Access Compliance Report

Public Rights-of-Way

(Curb Ramps)

Intersection ID: 10025885	Main Street: ELIZABETH_AV	Cross Street: N/A	Location: S
ADA ID: 187C60A6E7ED	Ramp Type: Perp	Initial Pass/Fail: Pass	Overall Compliance: No
		Severity Score: 0.25	
Codes/Mitigation Info/Possible Solution		Field Measurements/Component Compliance

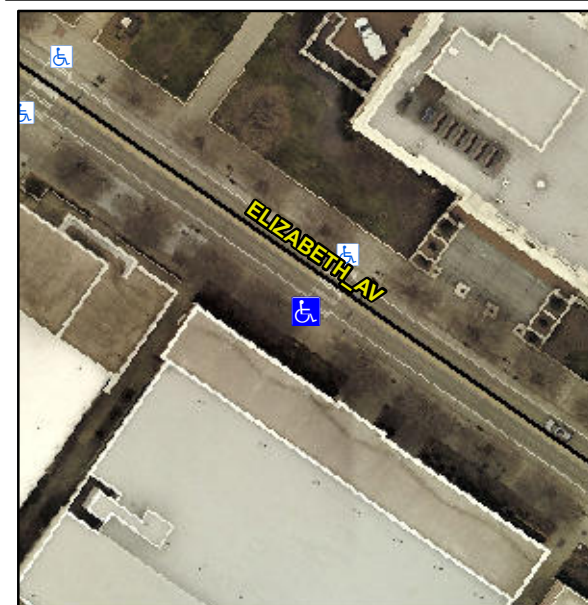
Not Found, R304.5.3

Compliance	Description	Data	Compliance	Description	Data
N/A	Ramp Length (in)	84.0	Yes	Ramp Slope (%)	5.6
Yes	Ramp Width (in)	96.5	No	Ramp XSlope (%)	4.0
N/A	Flare Type LT	Sloped	N/A	Flare Type RT	N/A
N/A	Flare Slope LT (%)	9.2	Yes	Flare Slope RT (%)	0.1
N/A	Flare Traversable LT?	Yes	N/A	Flare Traversable RT?	Yes
Yes	Landing Length (in)	60.0	Yes	DWS Provided?	Yes
Yes	Landing Width (in)	96.5	Yes	DWS Contrast?	Yes
Yes	Landing Slope (%)	1.2	Yes	DWS Length (in)	25.0
No	Landing X Slope (%)	4.0	Yes	DWS Full Width?	Yes
N/A	Landing Curb? (Y/N)	No	Yes	DWS Offset (in)	0.0
N/A	Shared Landing?	No			
Yes	Gutter Ponding?	No	Yes	Gutter Slope (%)	1.2
Yes	Gutter Lip Ht (in)	0.0	No	Gutter X Slope (%)	3.8
N/A	Painted X Walk1?	Yes	N/A	Painted X Walk2?	N/A
	X Walk 1 Direction	To NE		X Walk 2 Direction	N/A
N/A	X Walk 1 Width (in)	151.0	N/A	X Walk 2 Width (in)	N/A
	X Walk 1 Slope (%)	1.0		X Walk 2 Slope (%)	N/A
	X Walk 1 X Slope (%)	3.3		X Walk 2 X Slope (%)	N/A

Remove & Replace Entire Ramp.
Remove & Replace Gutter.
